## STAFF REPORT

PROPOSAL: **ACMA School Rebuild (CU2018-0016 / DR2018-0114 / SDM2018-0012)**

LOCATION: 11375 SW Center Street  
Assessor's Map # 1S110DB Tax Lot 2000

**FACILITIES REVIEW COMMITTEE  
TECHNICAL REVIEW AND RECOMMENDATIONS  
CU2018-0010/DR2018-0070/SDM2018-0012  
ACMA SCHOOL REBUILD**

SITE PLAN - OVERALL

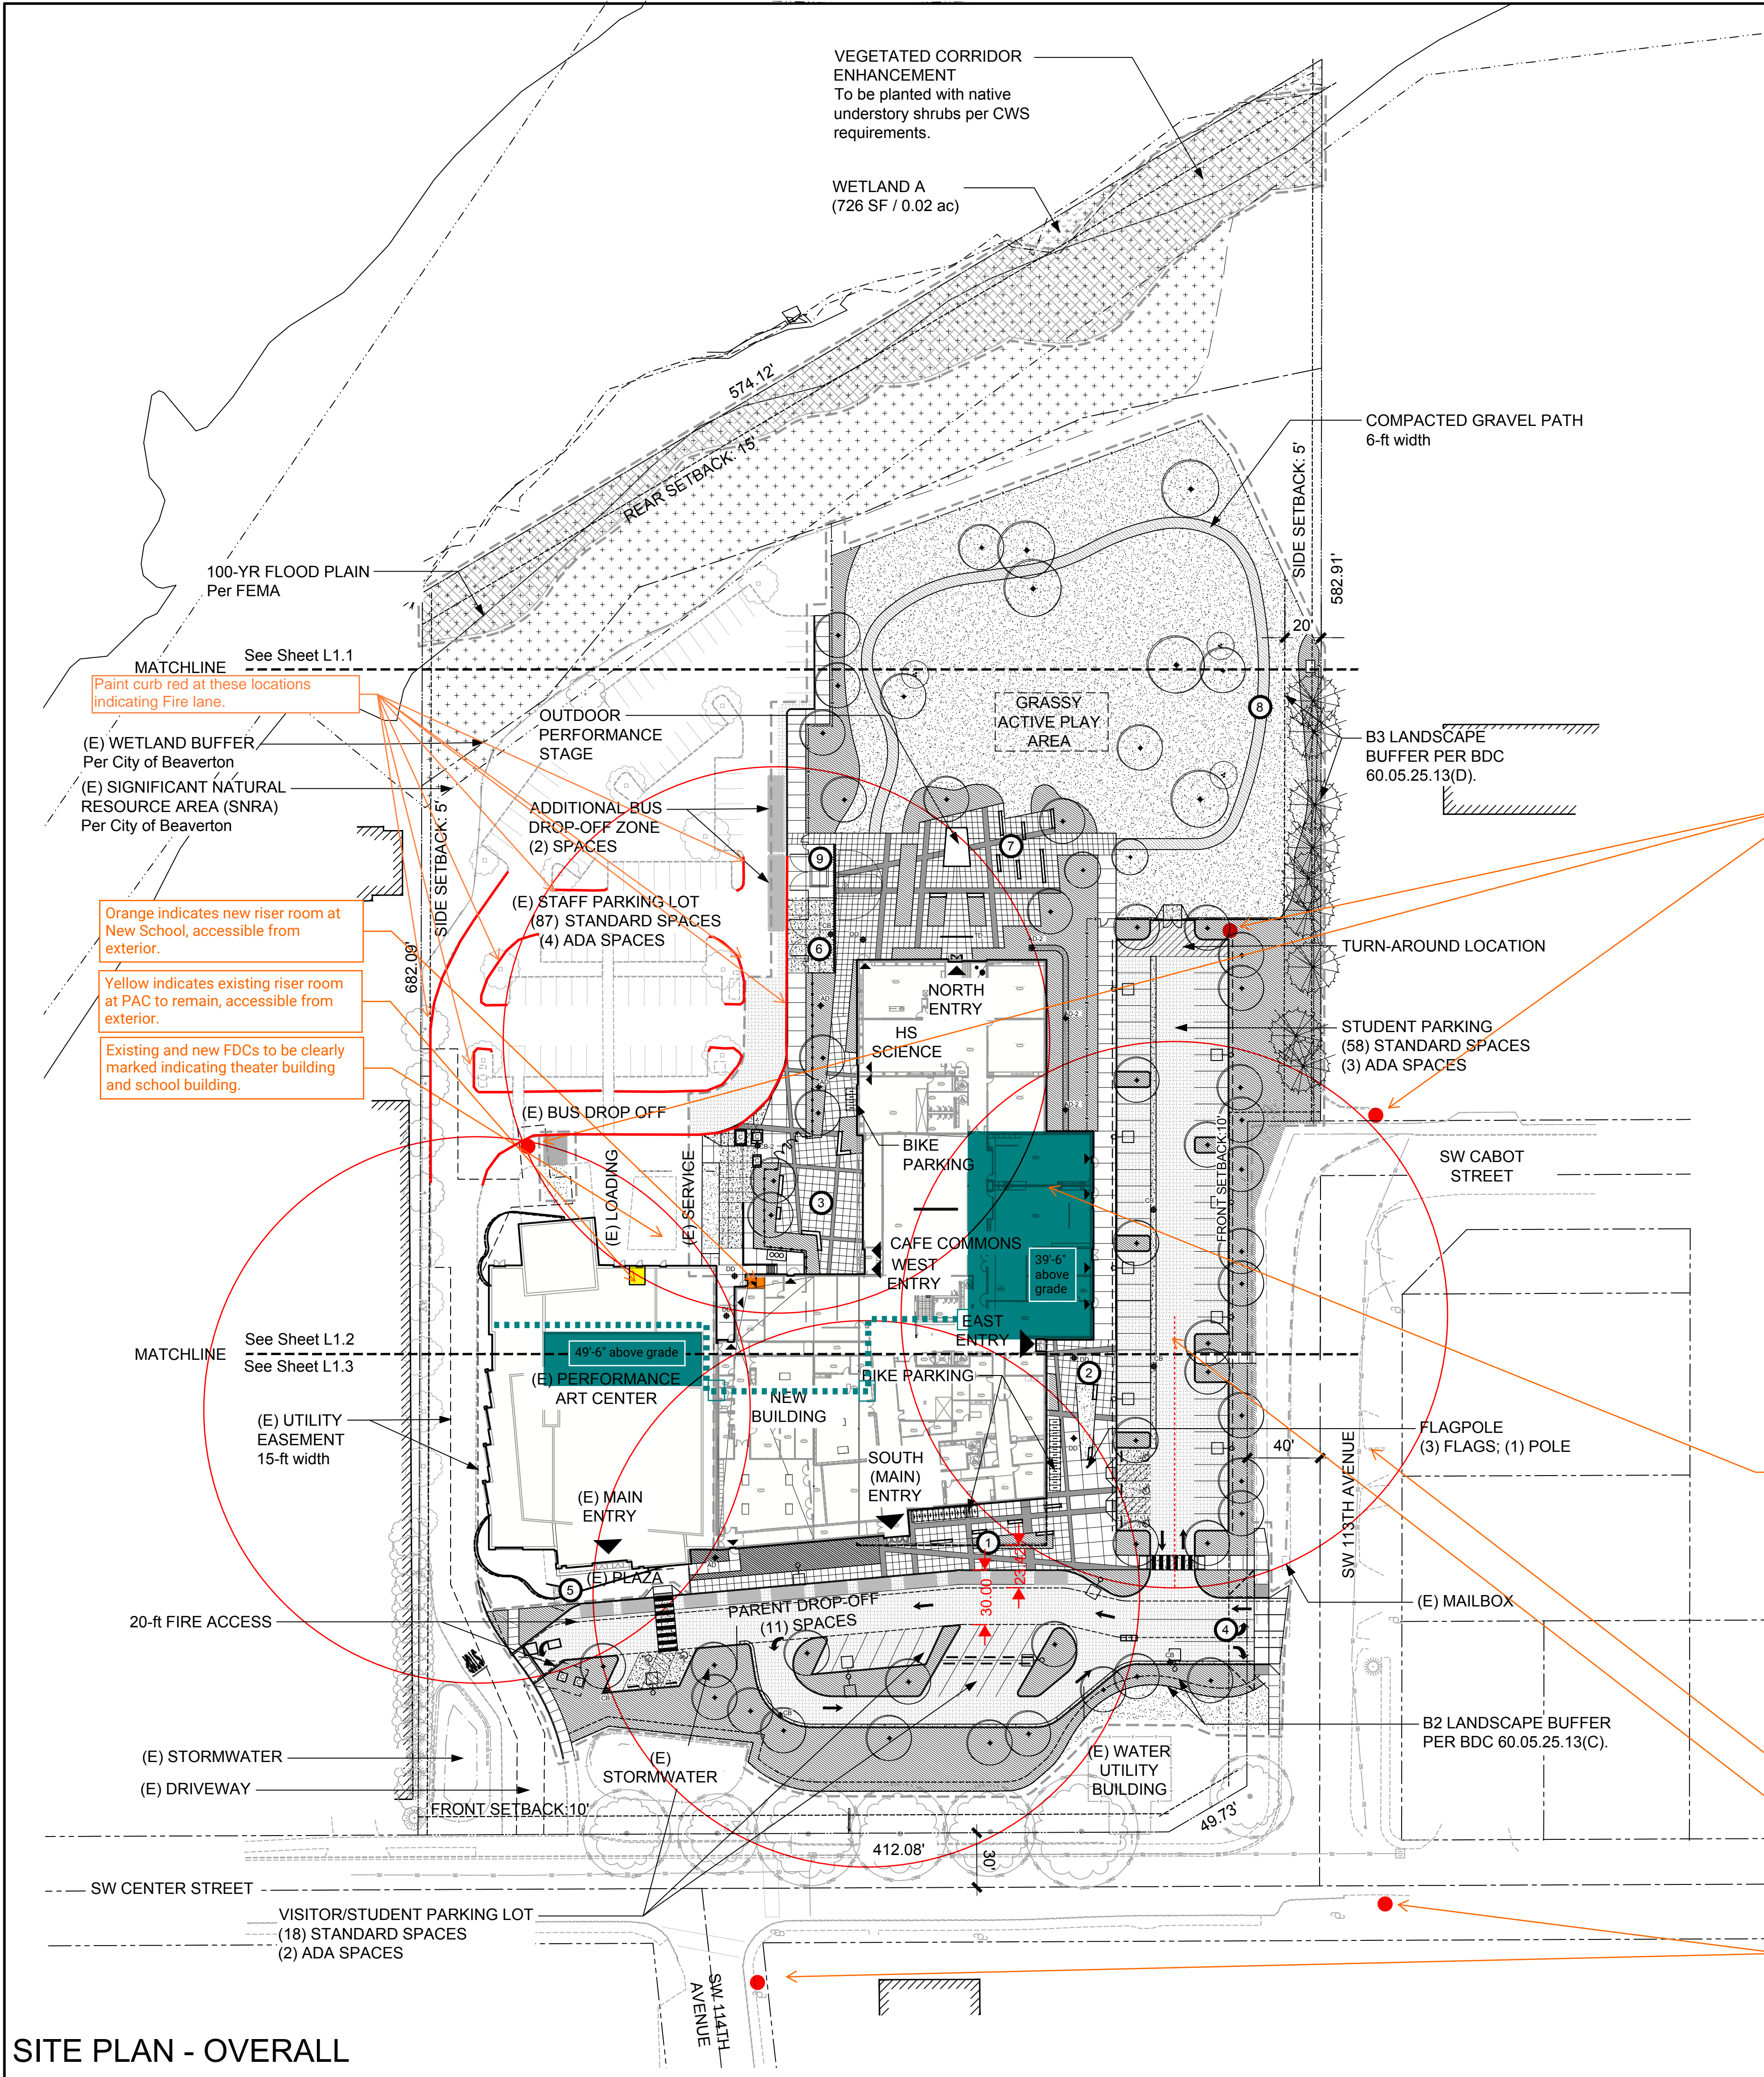
- New construction is Type 2B Construction, 2 stories, approximately 76,000 sf total.
- New construction will be fully sprinklered, but on a separate fire protection system from the PAC. Existing PAC building's riser room is on the north side of the PAC. New construction will have a riser room on the NW corner (*see site plan diagram*).

- Fire Department Connections (FDC): Two separate FDCs (one existing and one new) on NW side of buildings (*see site plan diagram*) to be labeled with durable metal signs identifying their uses, potentially identified as "Theater Building" and "School Building". Exact signage to be verified with TVFR prior to installation. Ease of understanding during an emergency is intent. New FDC to be located within 100' of existing hydrant. TVFR recommends (not required) using lockable Knox FDC plugs to reduce vandalism and reduce need to back flush FDC water lines.

- Hydrants: Two existing hydrants are on site and multiple hydrants are on adjacent streets (*see site plan diagram*). The two on-site hydrants have had fire flow testing (*see R&W Engineering letter*) and existing flow seems to be adequate per our understanding of the Oregon Fire Code. (*See DLR Group Memo*) No additional hydrants or pressure is required.

- Existing building is accessed within 150' of existing road to the east, and fire lanes on site on the west, northwest, and south. (*see site plan diagram*) No additional access roads are anticipated. No additional standpipes are necessary.
